# New Service Station at 2135 Washington Avenue

Service Station at 21-35 Washington Ave, corner of Cumberland  
2/13/63

Permit to construct a one story three-bay service station 62'6" x 29'4" as per revised plans and specifications received April 29, 1963 and in accordance with Mr. Sears letter of March 13, 1963 is being issued subject to compliance with the following:

Although the appeal under the Zoning Ordinance for new service station at the above named location in this City has been sustained conditionally, permit for its erection cannot be issued until information indicating compliance with Building Code requirements has been furnished. Rights granted under the appeal will expire unless work is started within six months of the date on which the appeal was sustained. Items and details in question are as follows:

882

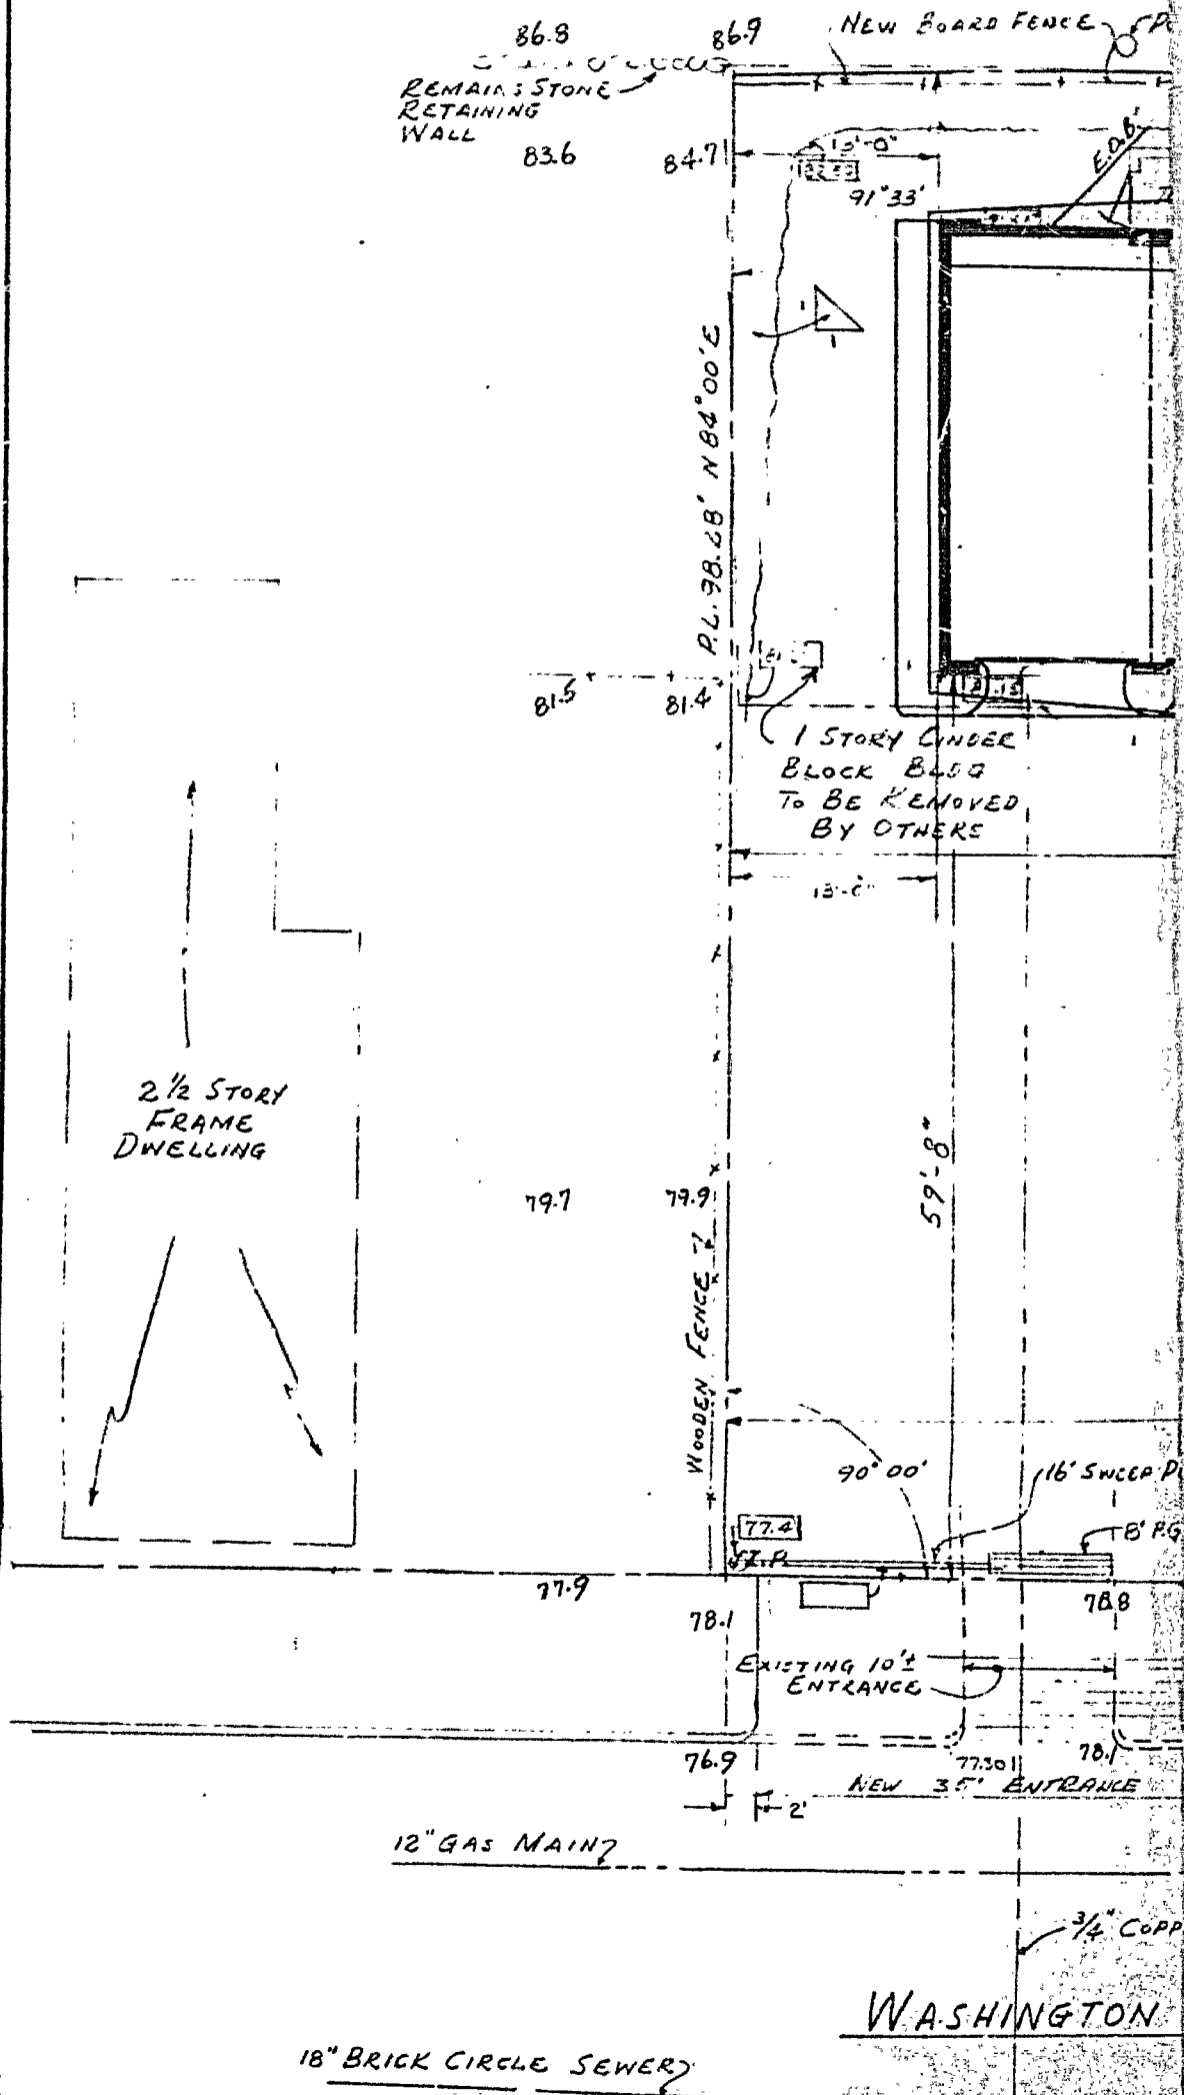
OK as to location and  
dimension of driveway opening.

OK as to location and  
dimensions of driveway openings.  
A.H. Connor
